Our Ref: 2205270/LLFA/04RA

RESPONSE TO CONSULTEE COMMENTS – Land at Palk Road, Havant (REF: APP/22/01231)

Ardent Consulting Engineers (hereafter referred to as 'Ardent') have been commissioned by Bellway Homes Ltd. (Wessex) to address comments raised by the Lead Local Flood Authority (LLFA) and the Environment Agency (EA) with respect to the proposed development on Land at Palk Road, Havant, PO9 1NL (planning application ref: APP/22/01231). Refer to the enclosed responses from the relevant consultees in **Appendix A**.

A2 Scale	Date	Designed by
1:500	MAY 23	TD
Drawn by	Checked by	Approved by
FH	CC	BC
Drawing Number	2108040-001	
Rev	D

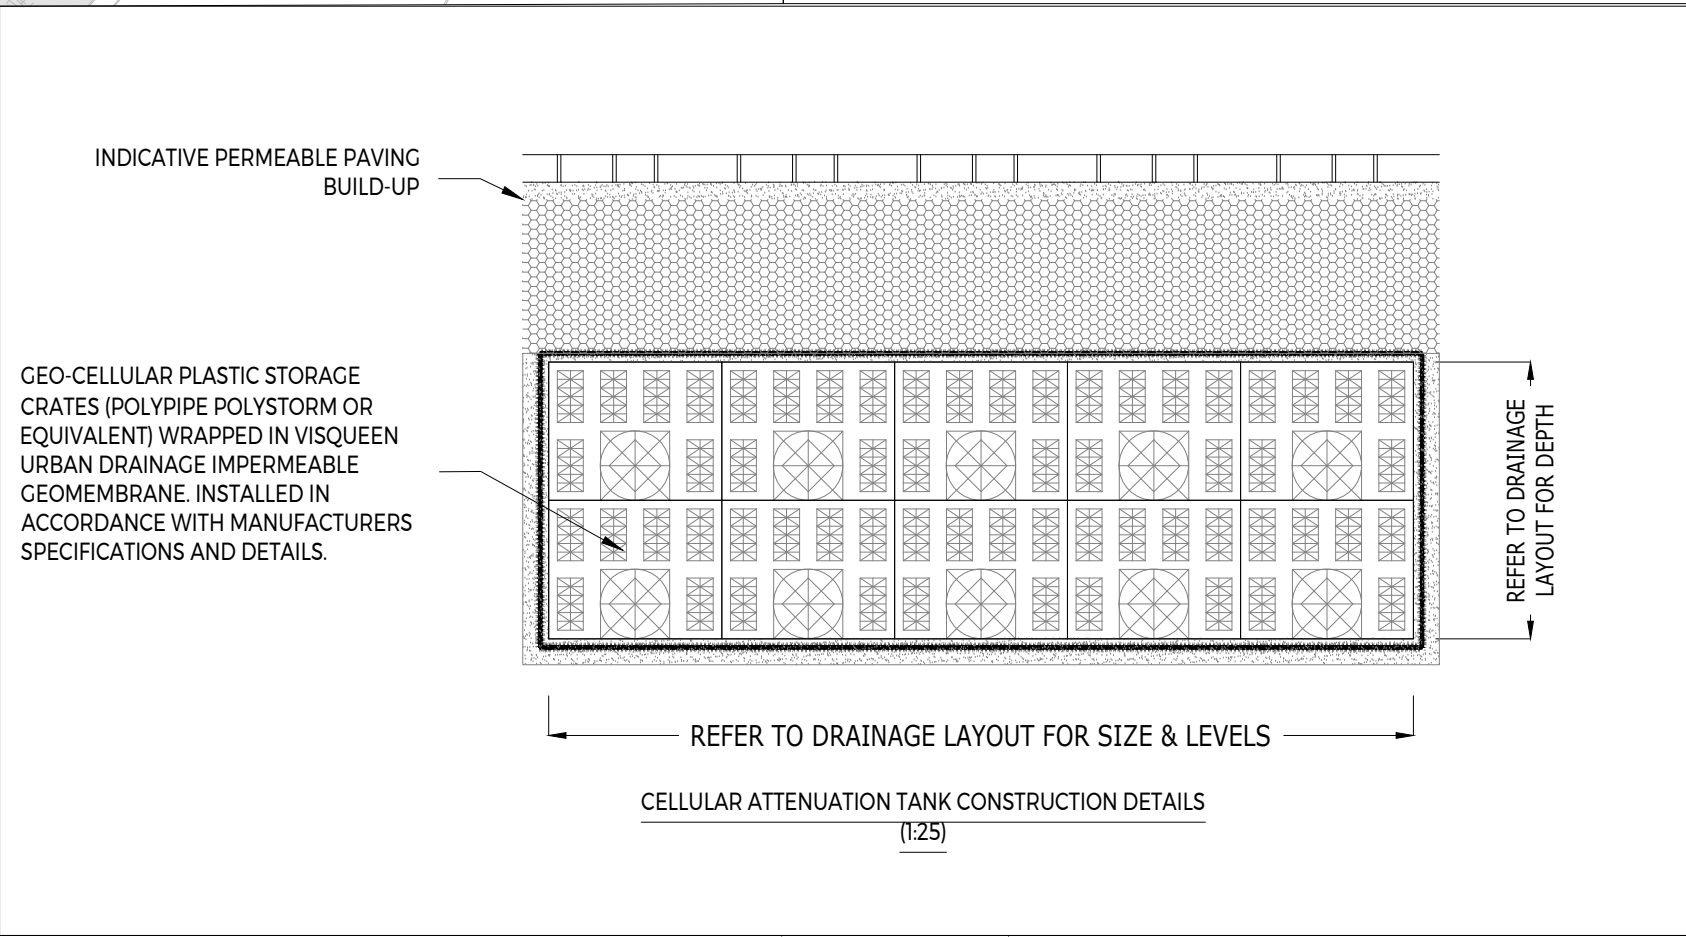
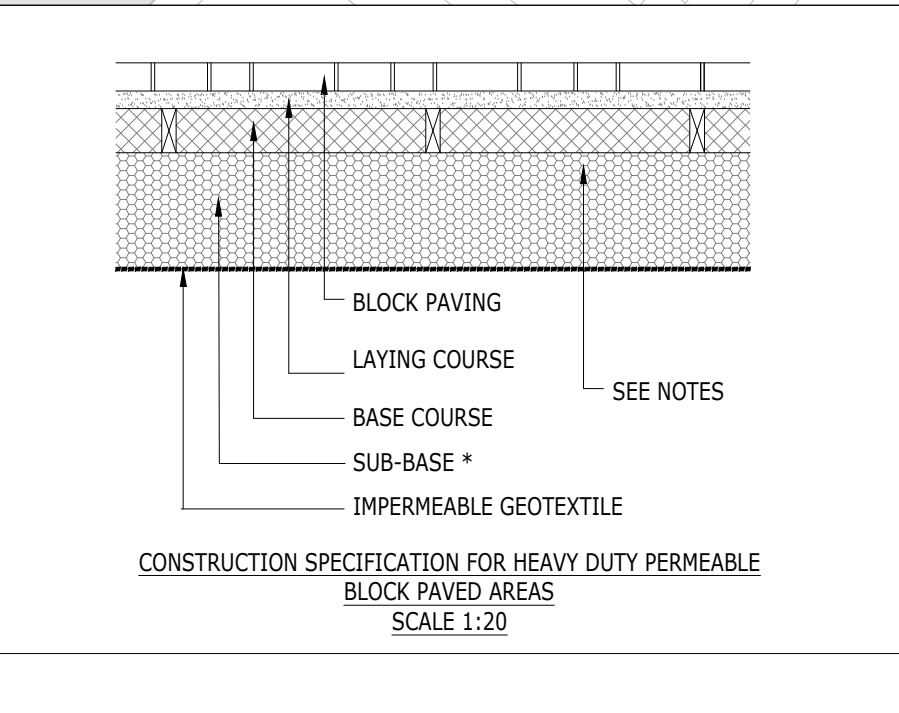
Permeable paving areas may need to be increased so that all runoff from roads is suitably treated prior to entering attenuation tanks.

Flooded extents should also be shown on the layout showing the flood exceedance flow routes.

The inclusion of above ground SuDS features is limited by the flood risk to the site which prevents any features being located within the open space in the south of the site. The extent of permeable paving has been increased on site to ensure all runoff from roads is suitable treated prior to entering the attenuation tanks. This is shown in the updated Drainage Strategy Drawing (2108040-001C) in **Appendix D**. The permeable paving has remained outside of areas including the existing Southern Water surface water sewer, as well as the proposed private foul water sewers. Permeable paving has also been avoided in areas expected to be required for utility connections to the proposed development.

The indicative extents of the minor flooding in the 1 in 100 year, including climate change, event have been included on the drainage strategy drawing (2108040-001D).

As stated in the FRA produced by Ardent (Ref. 2108040-01A), the surface water flood extents shown on site are largely associated with the Hermitage Stream. Flooding extents are shown on the Foul and Surface Water Drainage Strategy Drawing (Ref. 218040-001A). This shows the extents to be confined mostly to the southwest of the site and outside the extent of all residential and commercial development and is therefore of negligible significance.

Exceedance flow routes are identified on the Foul and Surface Water Drainage Strategy Drawing (Ref. 218040-001B), indicating flows will drain towards the highway network and subsequently flow towards the Hermitage Stream beyond the site's southern boundary.
